Project Name on Plan: Poniros Residence

Street Location: 97 High Street, Armonk, NY 10504

Application for Revision to Approved Plans

Description of Revision (In detail): Revised Layout of House interior.
Rear & Front patio, Driveway, walk to driveway.
Front GATE on driveway

FIRST FLOOR CONSTRUCTION PLAN

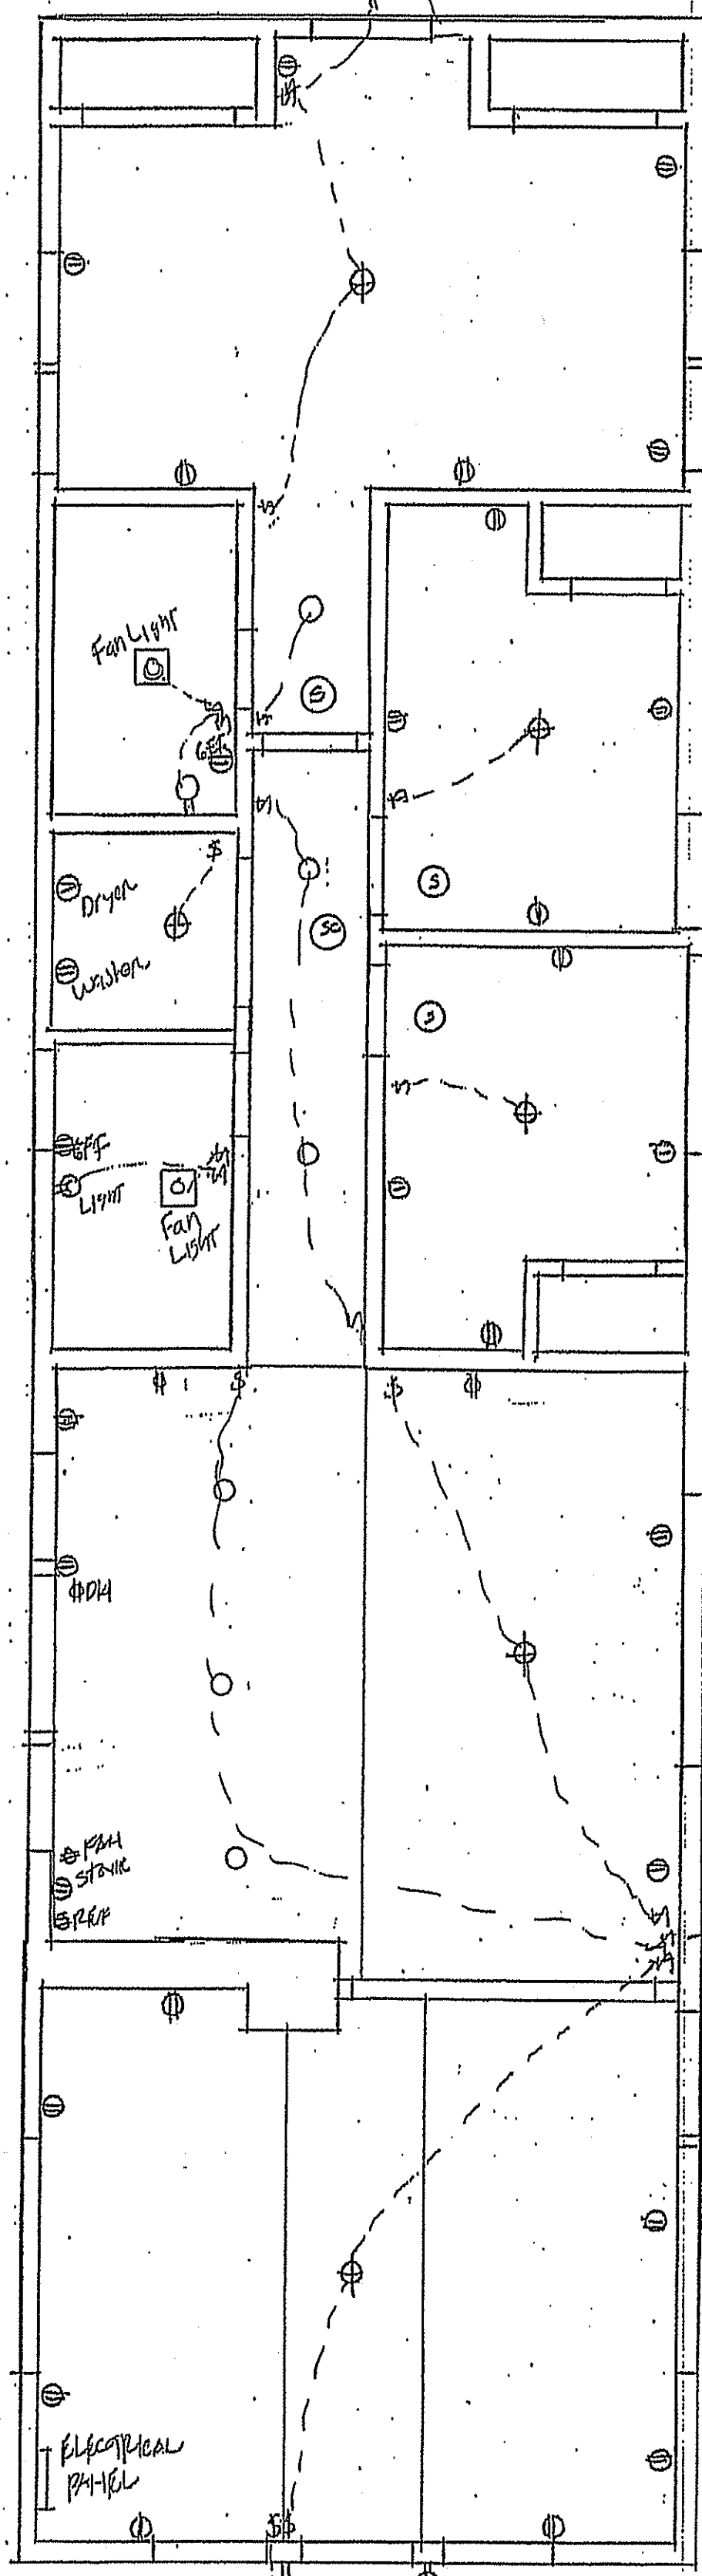
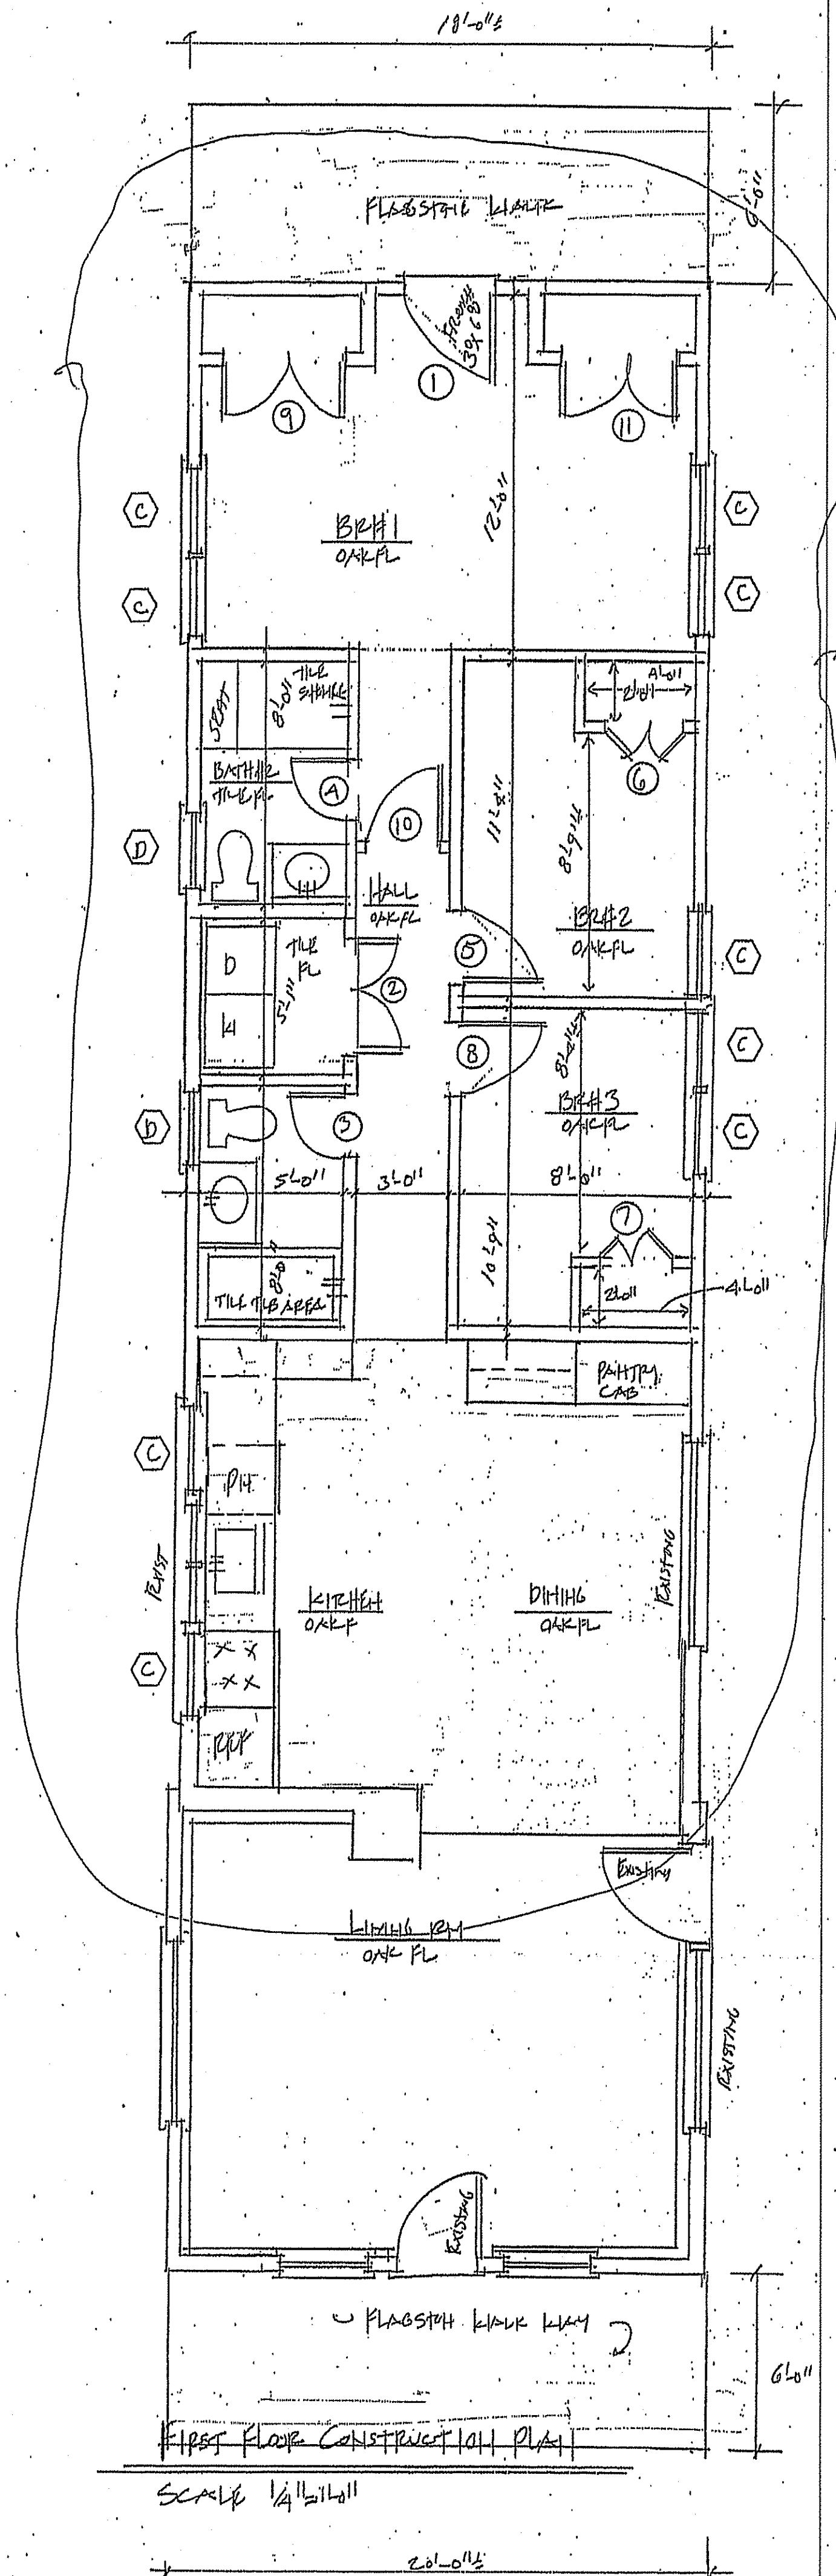
ISSUED FOR LAYOUT CHANGES 10/20/20
ISSUED FOR BLDG PERMITS 10/23/17
